PLANNER'S REPORT

TO: Adrienne Senter
FROM: Lynn Patterson
RE: Variance Application for Willingham Drive & Colville Avenue - The Village Walk at Hapeville
DATE: April 17, 2019

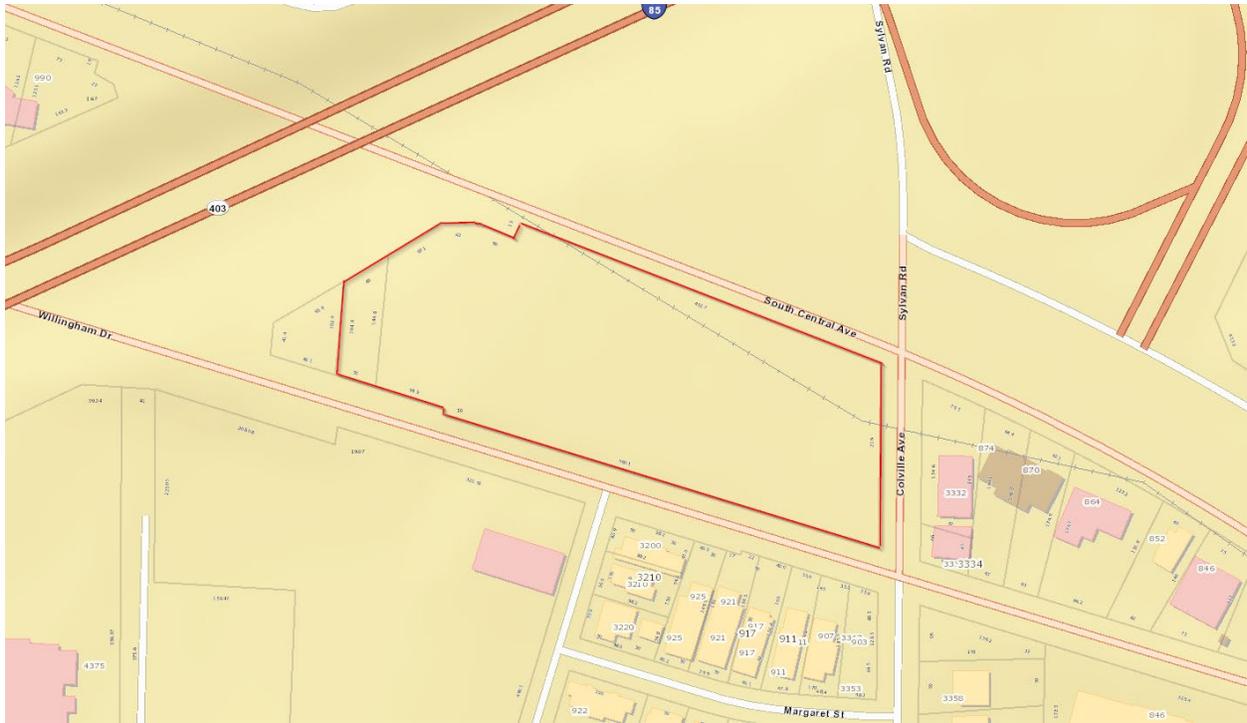
The proposal to reduce the parking for a commercial use is a major concern for this property. The Applicant has indicated three of the 32 provided parking spaces will be located in the residential area and has suggested that 13 more spaces running along a street behind several of the townhomes could be used to meet parking demand in the commercial area. First, the layout of the townhomes reflects a multi-use rather than mixed use approach. Encouraging the use of residential parking to meet commercial demand will result in a high volume of automobile and foot traffic in what is designed to be a private residential area (as indicated on the site plan with an optional residential gate). There is no proximal public or on street parking to capture overflow should the reduced parking lot requirements be met.

Second, the use of the proposed parking spaces in the residential area is complicated by (a) safety concerns, (b) site layout and conflict with Architectural Design Standards, (c) layout of the parking, and (d) optional residential gate as shown. The parking of cars in the residential area directly behind the townhomes for the use of patrons creates a potential safety concern. As discussed with the Chief of Police, the parking is located to the rear and not highly visible (e.g., a public street). Entering autos is an on-going issue in the Metro area and the City of Hapeville. Conflicts between commercial visitors and residents could be problematic as this is private property. Similarly, the property will belong to the HOA and all maintenance, issues and liability would become their responsibility.

The site layout does not adhere to the Architectural Design Standards, including residences fronting on a public street and no parking in the supplemental area. The parallel parking proposed along South Central violates this code requirement – even with a fence. The optional residential gate as shown on the site plan, if installed, would preclude the use of the proposed 3 spaces (not including the additional 13 spaces).

The site plan also shows an excess of parking beyond 110% of the dimensional requirements. This would require Board of Appeals approval at a separate meeting.
